SERVICE BULLETIN

No. 636A

Piper Aircraft Corporation

<u>Subject:</u>	Bulkhead Reinforcement at STA .317.75
<u>Reason for Revision:</u>	Change <u>Compliance Time</u> , and <u>Purpose</u> .
<u>Models Affected:</u>	<u>Serial Numbers Affected:</u>
PA-31/31-300/31-325 Navajo	31-2 through 31-7912039
PA-31-350 Chieftain	31-5001 through 31-7952071
<u>Compliance Time:</u>	Within the next one hundred (100) hours of operation or at the next regularly scheduled inspection event, whichever occurs first, and every one hundred (100) hours of operation thereafter unless/until Kit 763 917 or Kit 764 028 is installed or if cracks are found, in which case Kit 764 028 <u>must</u> be installed.

VIEW LOOKING AFT AT STA. 317.75 AFT FUSELAGE BULKHEAD

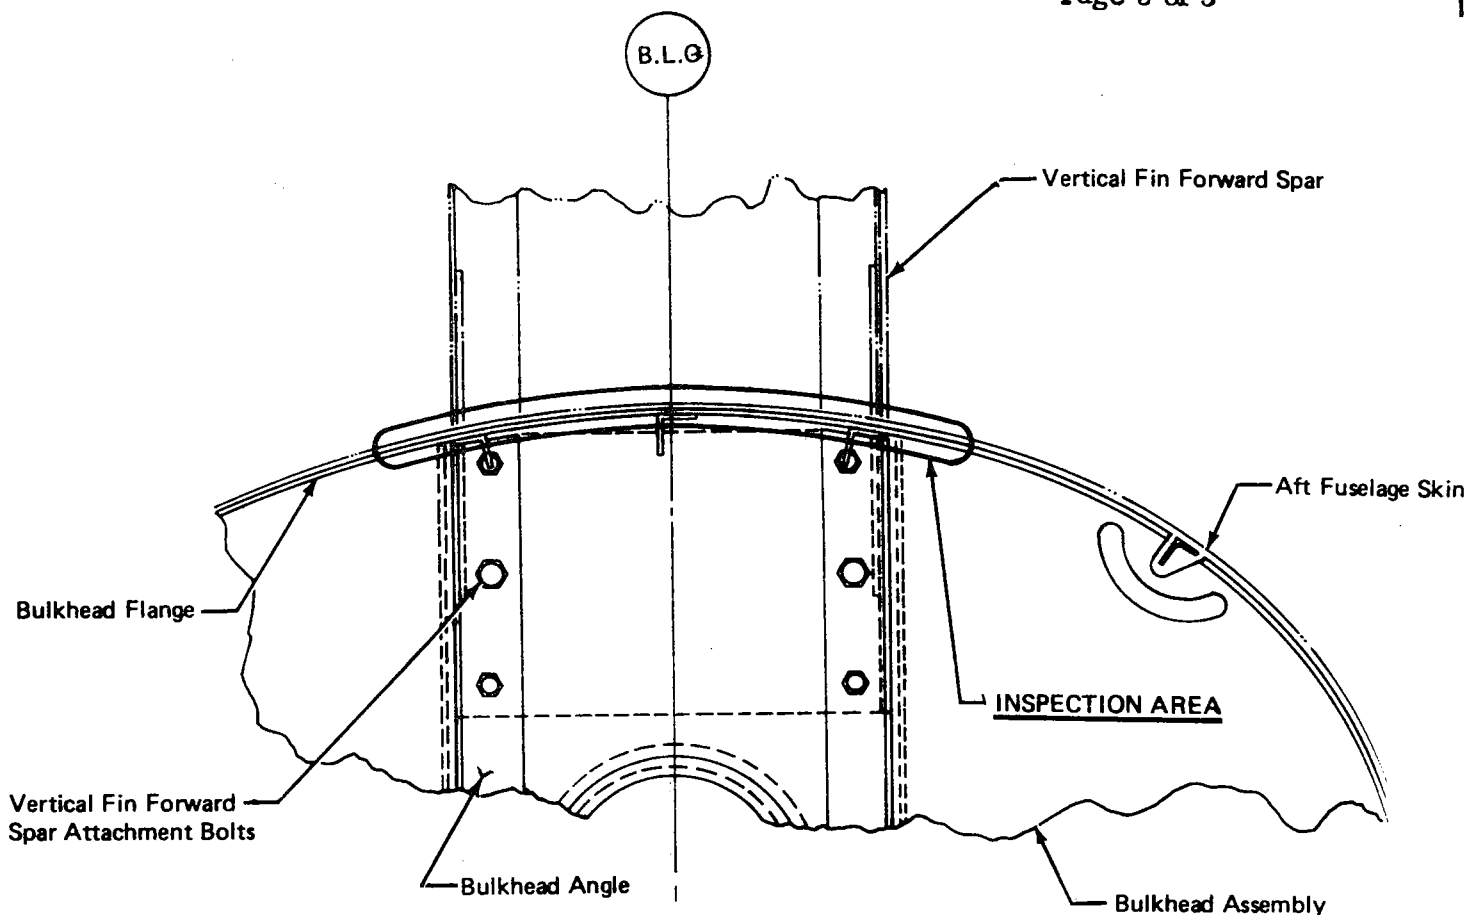
In several of the above listed aircraft, instances have occurred of cracks developing in the bulkhead flange area of STA. 317.75 at the attachment point for the vertical fin forward spar. If left unattended, this condition could eventually result in the loss of structural integrity of the vertical fin forward attachment. This condition has been limited to aircraft with two thousand (2000) or more hours of operating time.

1. Gain access to the forward side of Sta. 317.75 aft fuselage bulkhead by removing the right side access panel (aft of Sta. 274 bulkhead on aircraft so equipped) or by removing the interior closeout panel at Sta. 274.
2. Inspect the upper section of Sta. 317.75 bulkhead for evidence of cracks in the bulkhead flange area. Refer to sketch for inspection area. Use a 10X magnifying glass.
 - a. If no cracks are found, the bulkhead must be inspected at each 100 hours of operation unless Bulkhead Reinforcement and Drag Angle Installation Kit P/N 763 917 is installed.
 - b. If cracks are found, Bulkhead Reinforcement and Drag Angle Installation Kit P/N 764 028 must be installed prior to further flight.
3. Reinstall exterior and/or interior access panel(s).
4. Make proper Logbook entry of compliance with this Service Bulletin.

If NO cracks are found during inspection, one (1) each per aircraft, Piper Part Number 763 917, Bulkhead Reinforcement and Drag Angle Installation Kit.

If cracks ARE found during inspection, one (1) each per aircraft, Piper Part Number 764 028 Bulkhead Reinforcement and Drag Angle Installation Kit.
